Access Compliance Report

Public Rights-of-Way (Curb Ramps)

Intersection ID: 51212	Main Street: PROVIDENCE_ROW_LN	Cross Street: ARDREY_KELL_RD	Location: NW
ADA ID: 7C7CAEF48105	Ramp Type: Perp	Initial Pass/Fail: Fail	Overall Compliance: No
Severity Score: 12.5			
Codes/Mitigation Info/Possible Solution		Field Measurements/Component Compliance

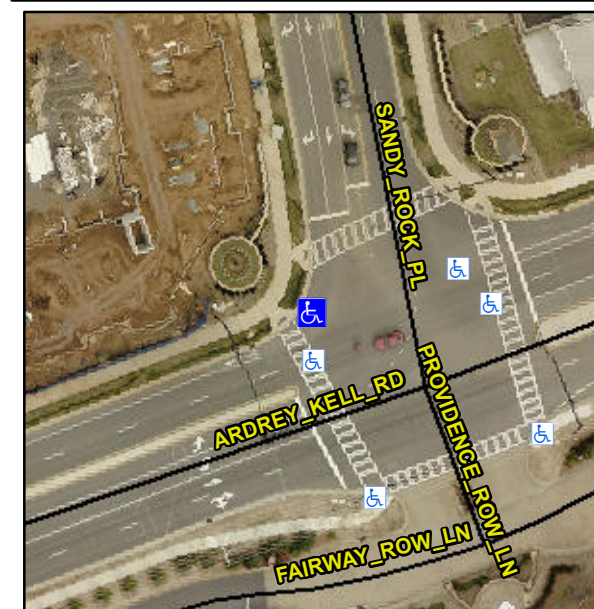
R304.2.2

Compliance	Description	Data	Compliance	Description	Data
N/A	Ramp Length (in)	96.0	No	Ramp Slope (%)	8.6
Yes	Ramp Width (in)	55.0	Yes	Ramp XSlope (%)	0.1
N/A	Flare Type LT	N/A	N/A	Flare Type RT	N/A
N/A	Flare Slope LT (%)	N/A	N/A	Flare Slope RT (%)	N/A
N/A	Flare Traversable LT?	N/A	N/A	Flare Traversable RT?	N/A
N/A	Landing Length (in)	N/A	N/A	DWS Provided?	N/A
N/A	Landing Width (in)	N/A	N/A	DWS Contrast?	N/A
N/A	Landing Slope (%)	N/A	N/A	DWS Length (in)	N/A
N/A	Landing X Slope (%)	N/A	N/A	DWS Full Width?	N/A
N/A	Landing Curb? (Y/N)	N/A	N/A	DWS Offset (in)	N/A
N/A	Shared Landing?	N/A			
N/A	Gutter Ponding?	N/A	N/A	Gutter Slope (%)	N/A
N/A	Gutter Lip Ht (in)	N/A	N/A	Gutter X Slope (%)	N/A
N/A	Painted X Walk1?	Yes	N/A	Painted X Walk2?	N/A
	X Walk 1 Direction	To E		X Walk 2 Direction	N/A
N/A	X Walk 1 Width (in)	113.0	N/A	X Walk 2 Width (in)	N/A
	X Walk 1 Slope (%)	0.2		X Walk 2 Slope (%)	N/A
	X Walk 1 X Slope (%)	2.6		X Walk 2 X Slope (%)	N/A

Remove & Replace Entire Ramp.
